P0766-0009
May 8, 2026

Re: **Request for Wetlands Conditional Use Permit Review
1 Franklin Ave - New Franklin School Upgrades**

To: Kate Homet, Environmental Planner & Sustainability Coordinator

Figure 2

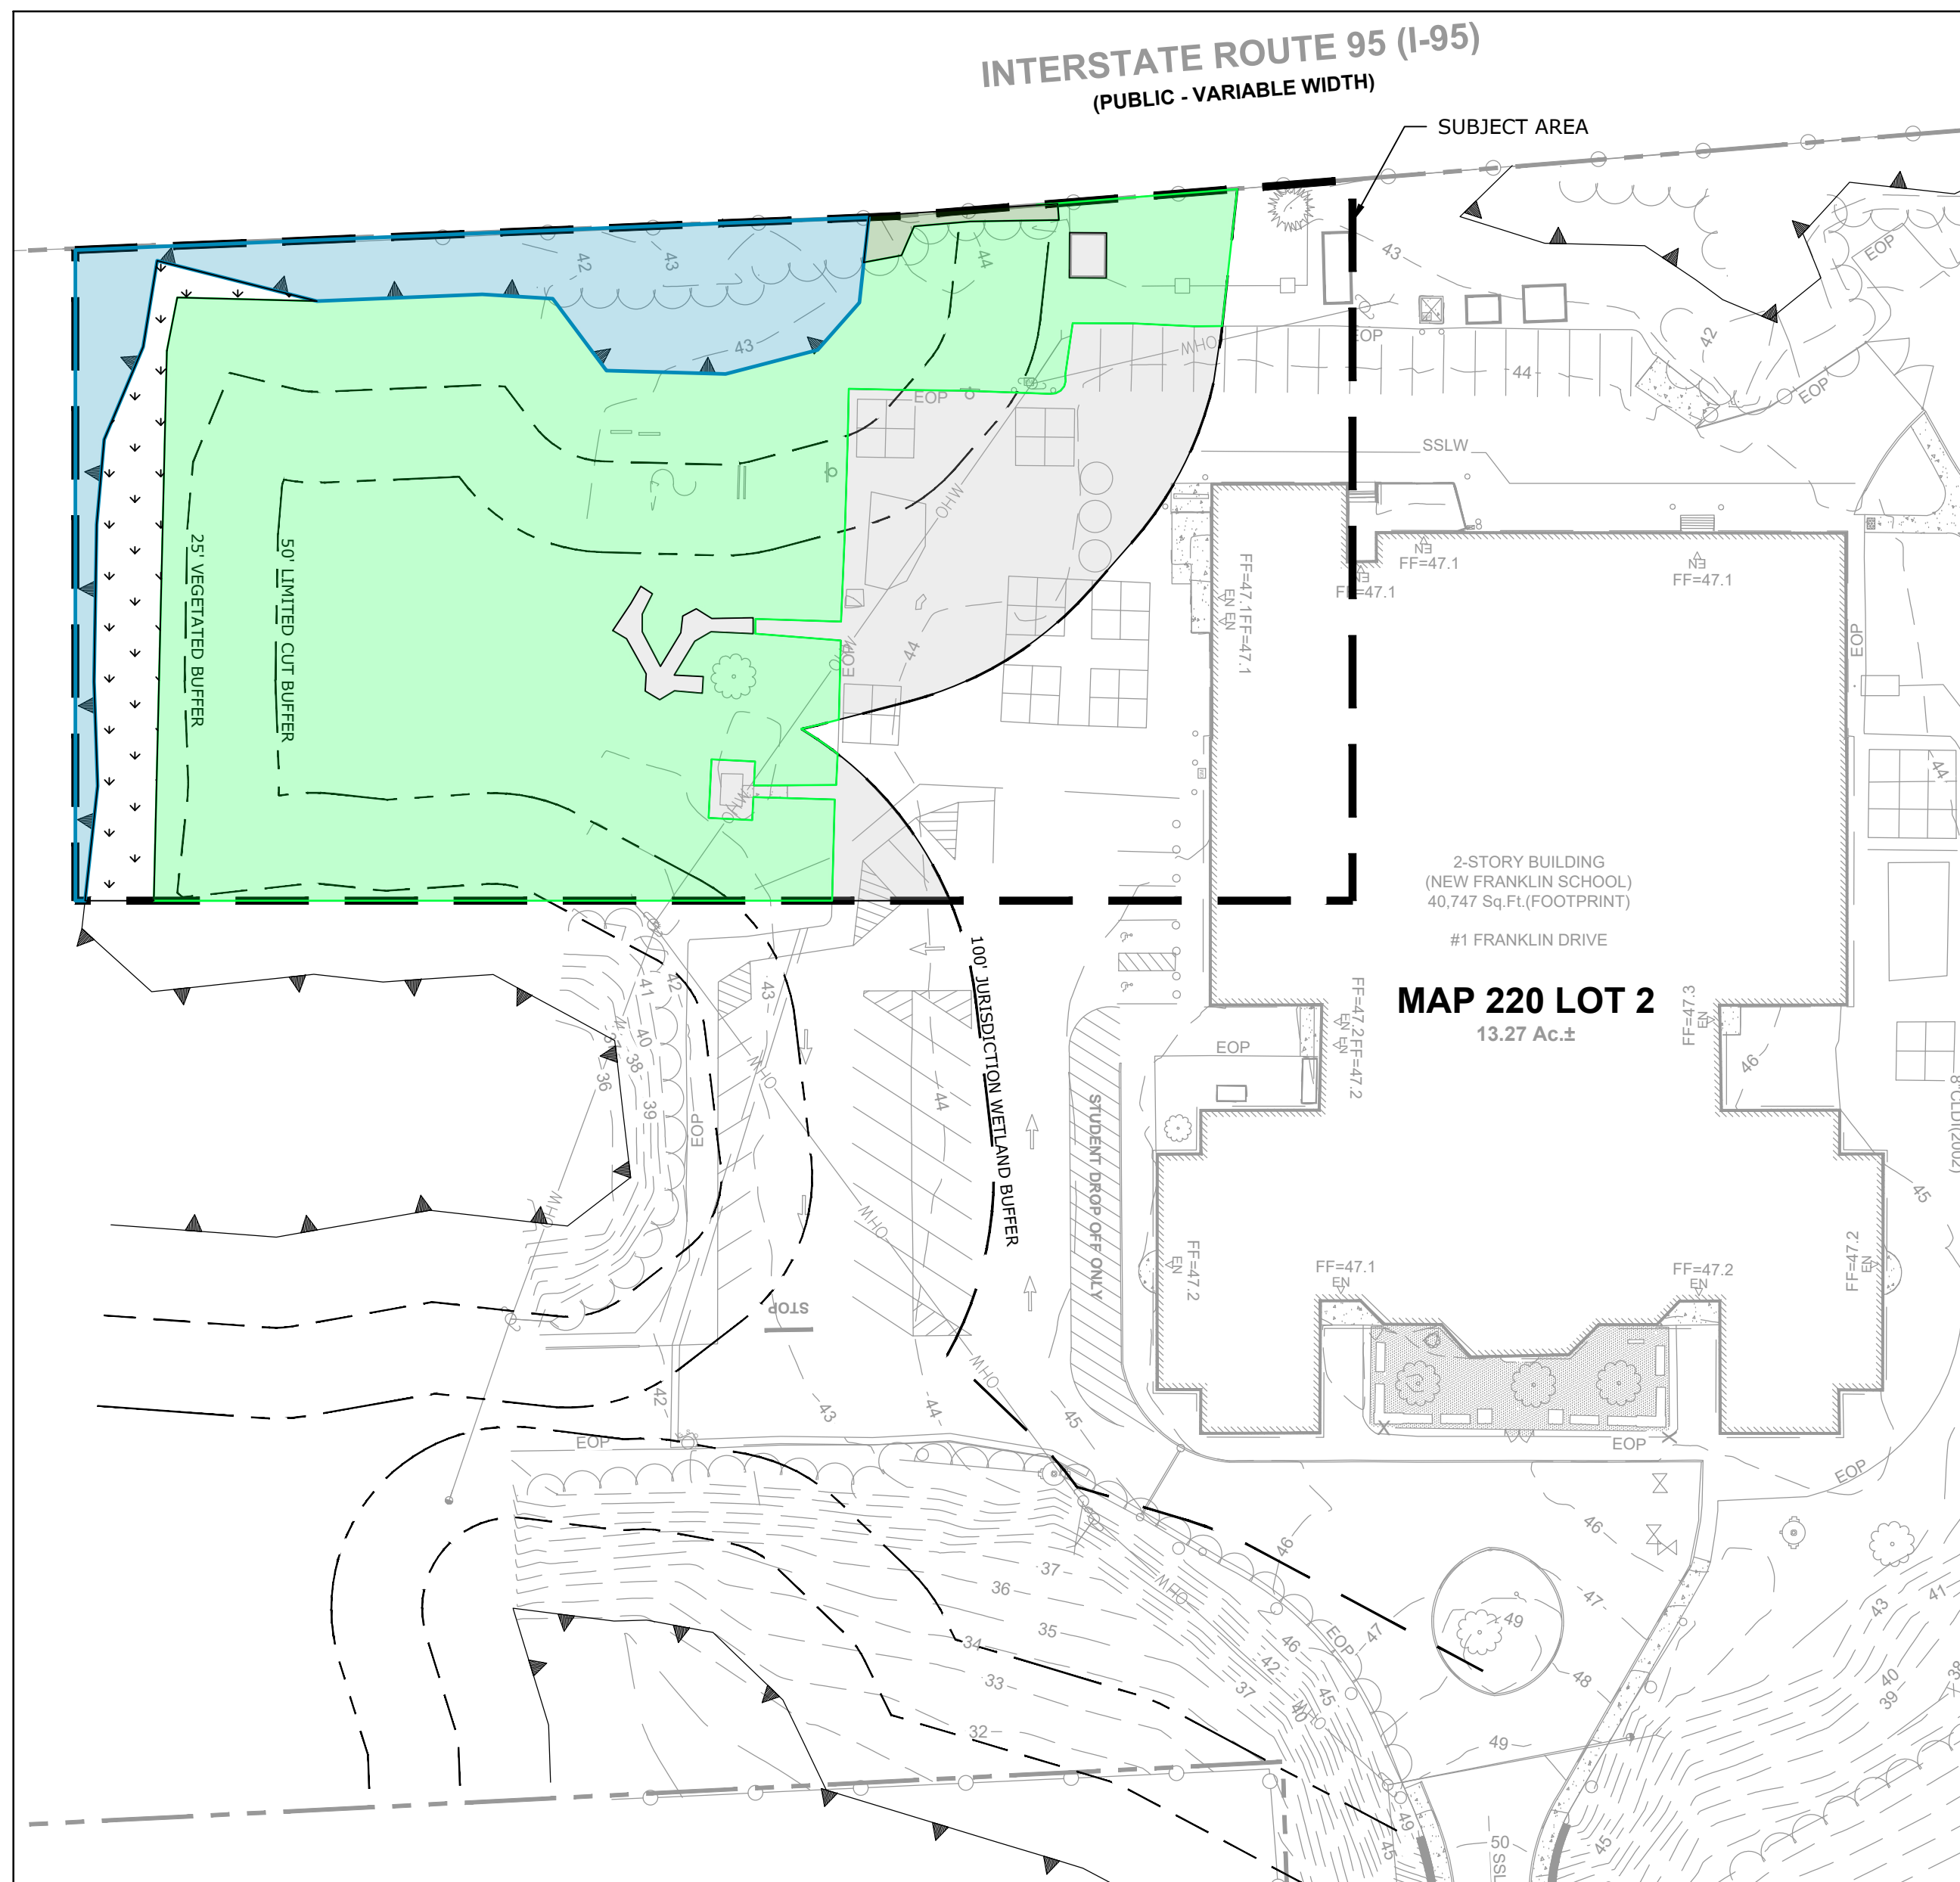
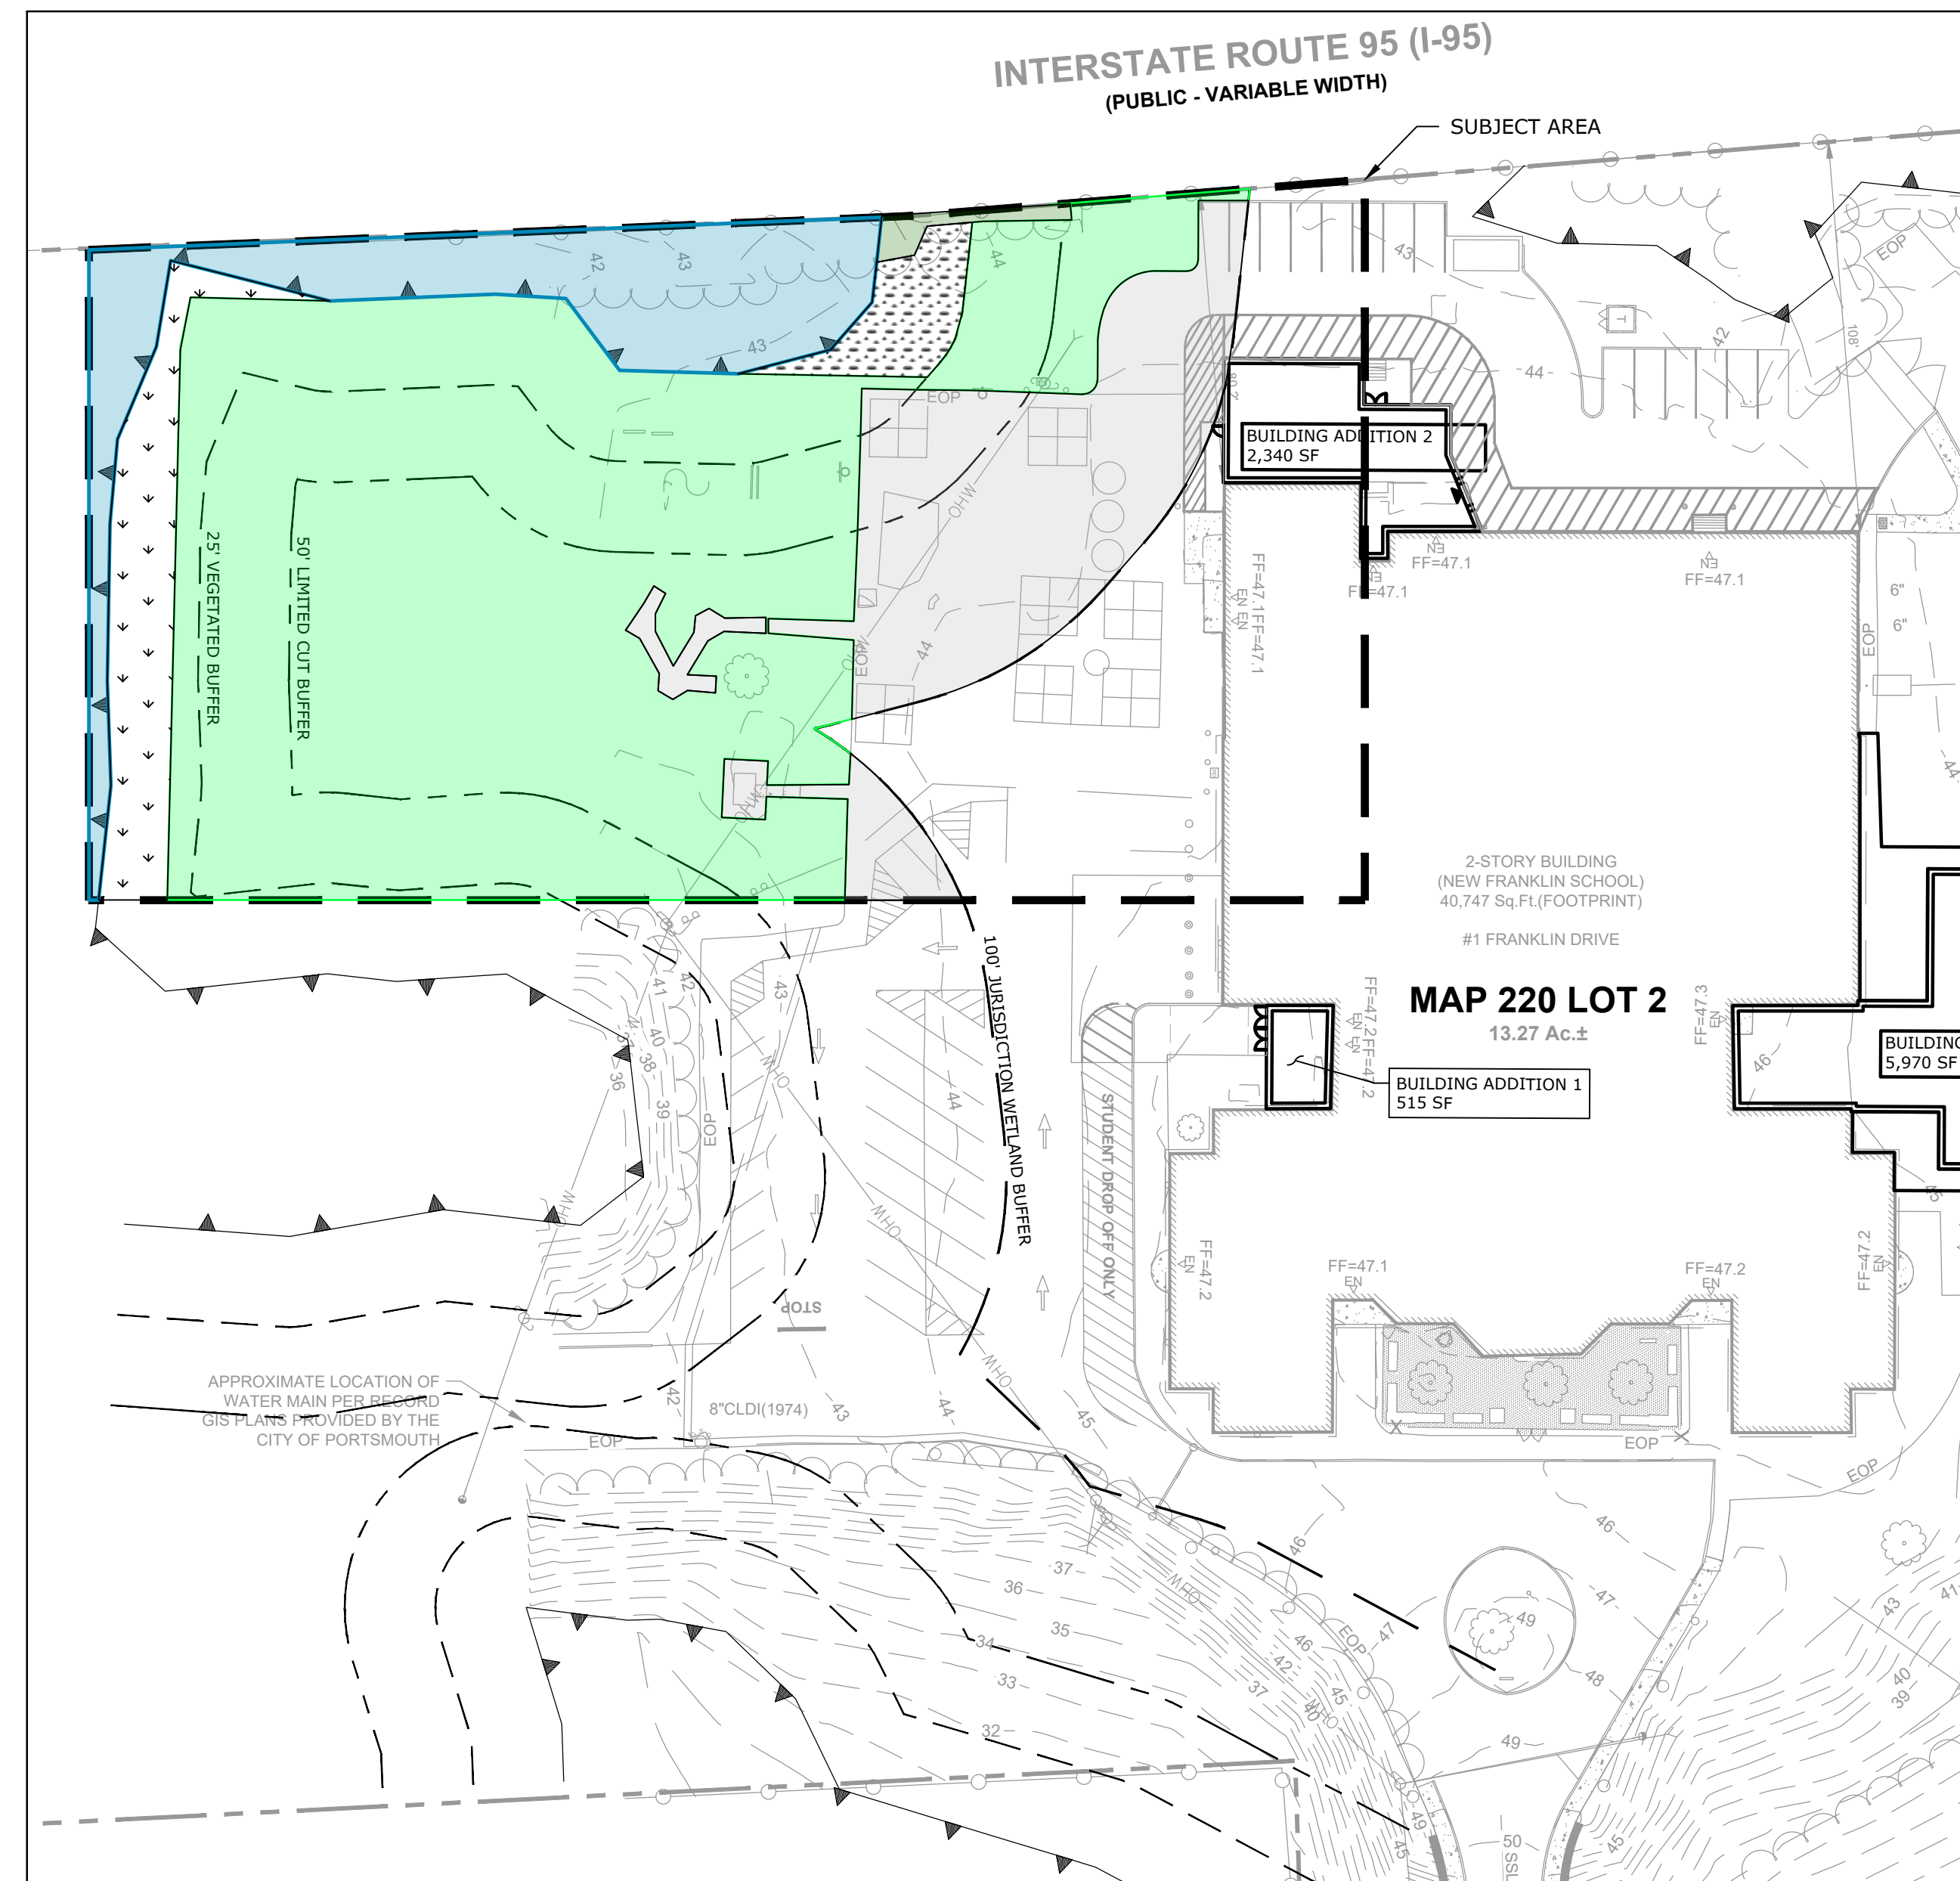
- 1. Section 10.1017.22 (3) of the City of Portsmouth Zoning Ordinance requires you to provide the following info: *More than 250 sq. ft. of alteration to the wetland buffer (regardless of the amount of alteration to the wetland): a description of the 100-foot buffer including vegetation type, the percent of the buffer with invasive species, and the percent of the buffer that is paved or developed.***

See "Wetland Buffer Surface Cover Exhibit". The existing 100' wetland buffer within the subject area consists primarily of maintained lawn/grass with impervious parking areas, and a small area of existing trees, upland wetland vegetation, and a small area identified as green ash.
